July 22, 2020

Re: Cross Creek PA-1C (#1447442) Response to Pre-Application Comments

Planning Department

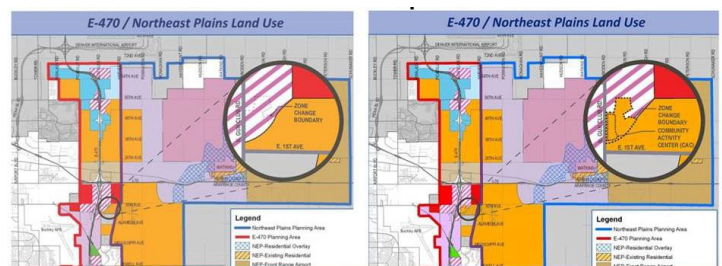
Expectations are for the Preliminary Plat to initially apply to the site to the south of the east/west roadway with the site to the north to be a second phase that illustrates a north/south connection between the 2 sites.

Response: That is correct.
